# Sound Transit III

## ***Guideway and Station Location***

*Preparing for Station Area and TOD planning*

# Stadium

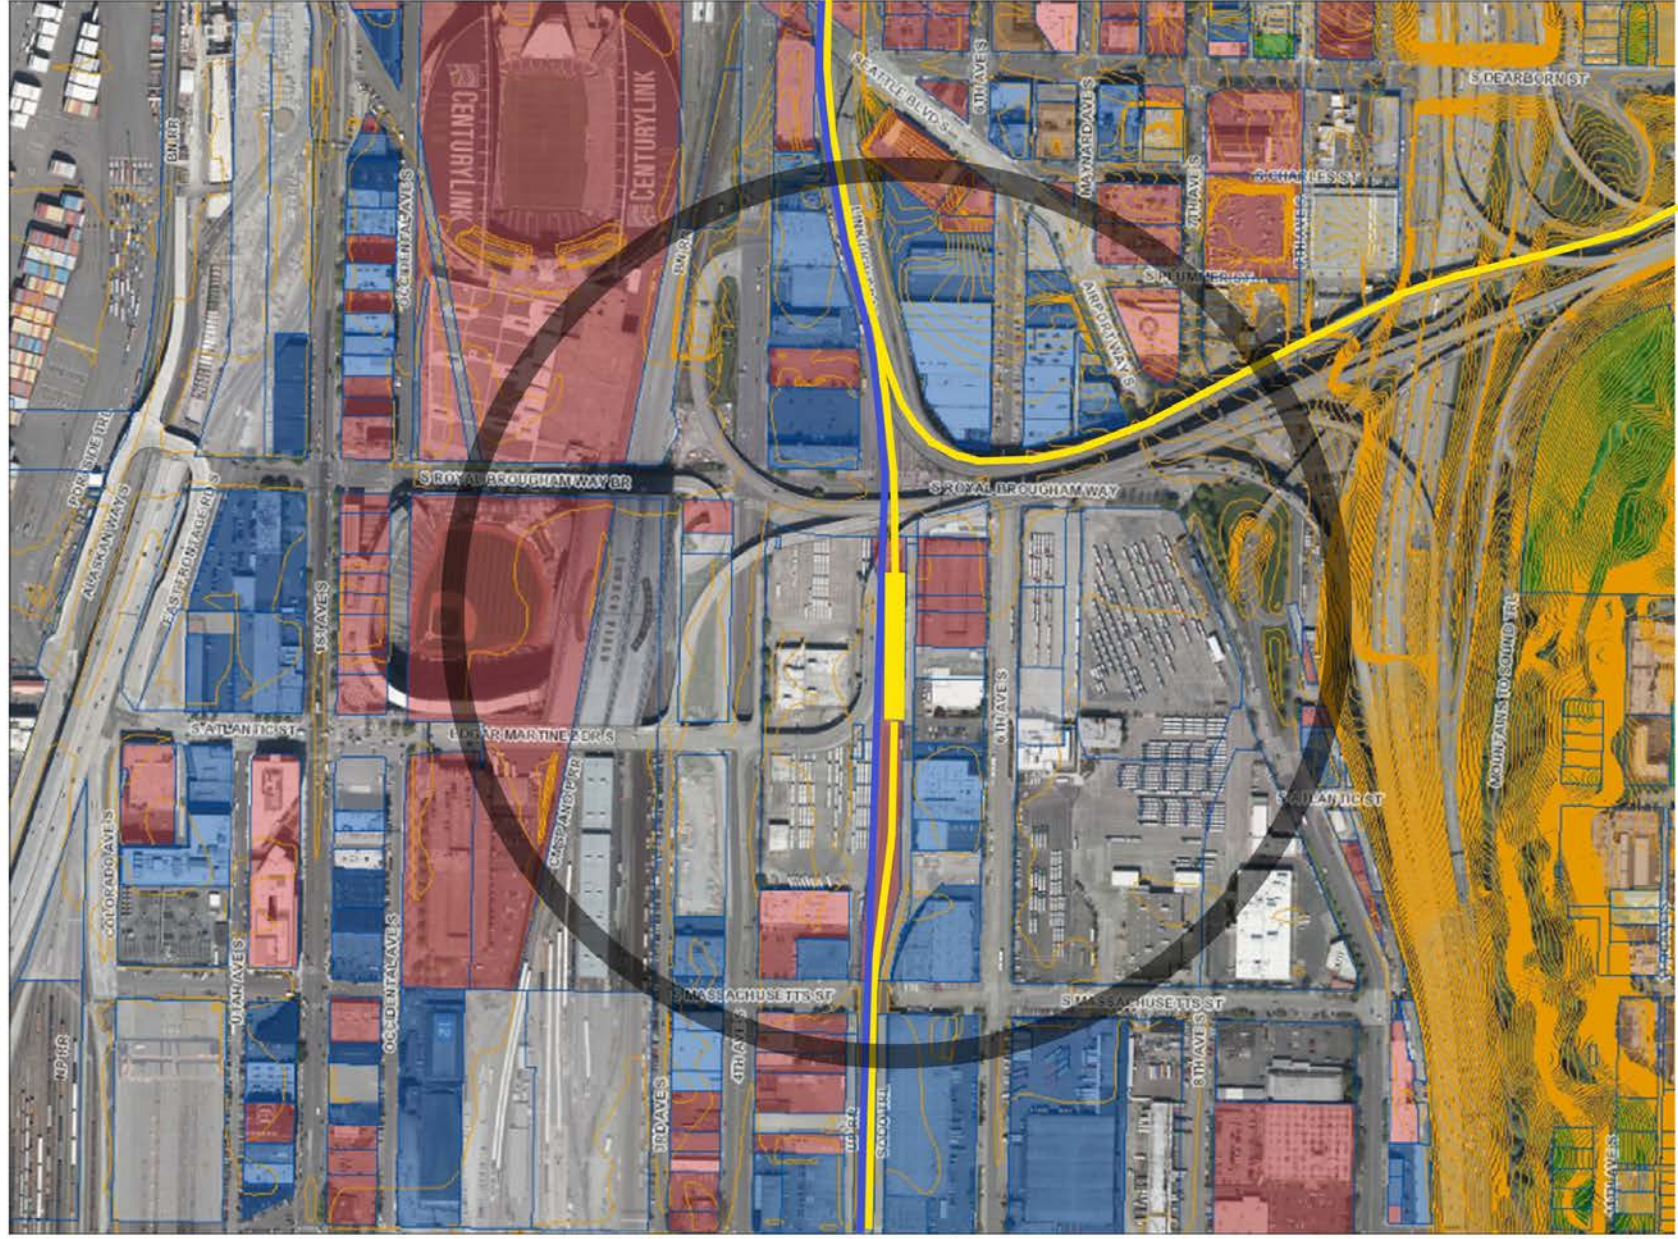
- Enhance stadium connections
- Explore land uses and pedestrian connections in the vicinity

# Delridge Station

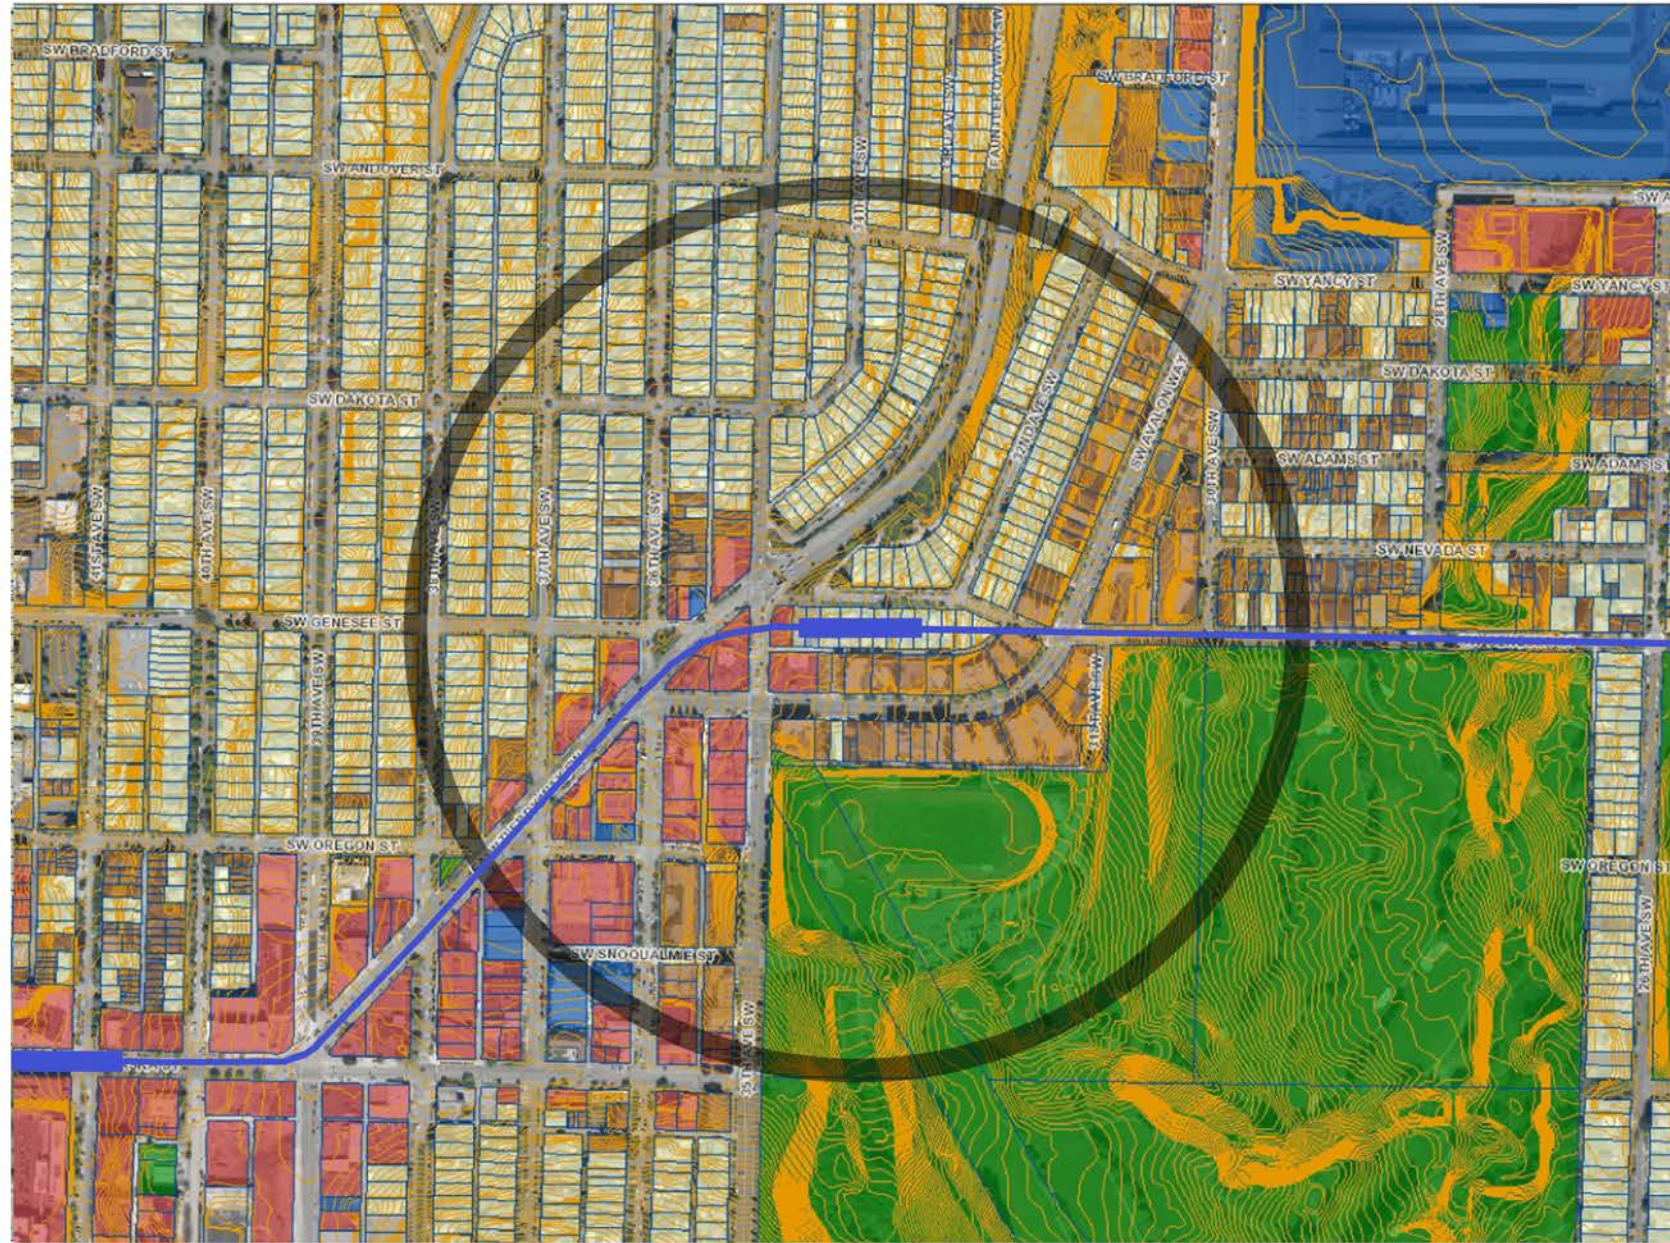
- Transit transfer point
- High guideway in small-scale neighborhood area
- Integrate station into co-developed TOD to help mitigate scale
- Limited worker-residential density currently
- Potential for TOD on surface lots
- Consider shifting station to the south
